Appl. No. 10/074,319

Amdt. Dated October 12, 2004

Reply to Office Action of June 9, 2004

DRAWING AMENDMENTS

FIG. 1 PRIOR ART

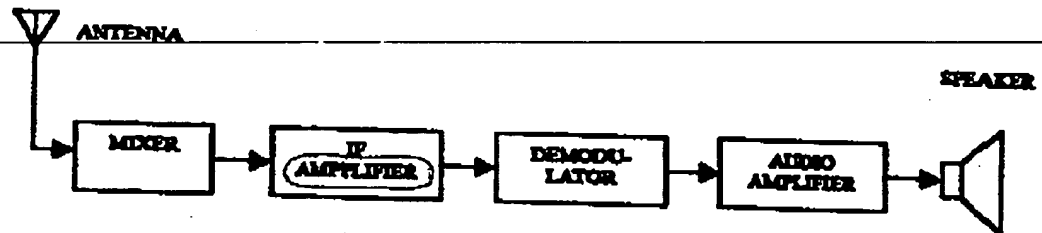
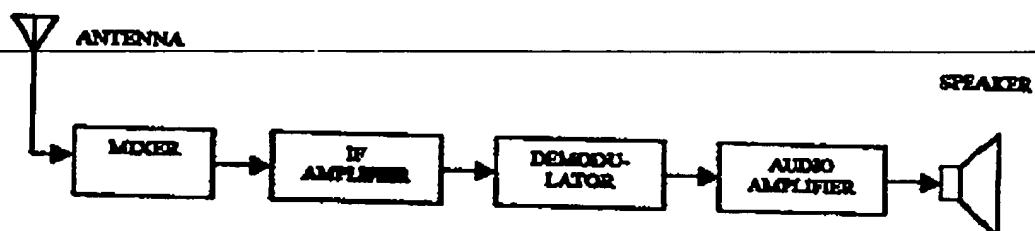
The attached sheet of drawings includes changes to Fig. 1 and Fig. 2. This sheet includes Figs. 1-2 and replaces the original sheet. In Figs. 1-2, a previously misspelled element "IF ampplifier" were changed to "IF amplifier".

Please approve the drawing changes that are marked in red on the accompanying "Annotated Sheet Showing Changes" of Figs. 1-2. A formal "Replacement Sheet" of amended Figs. 1-2 is also enclosed.
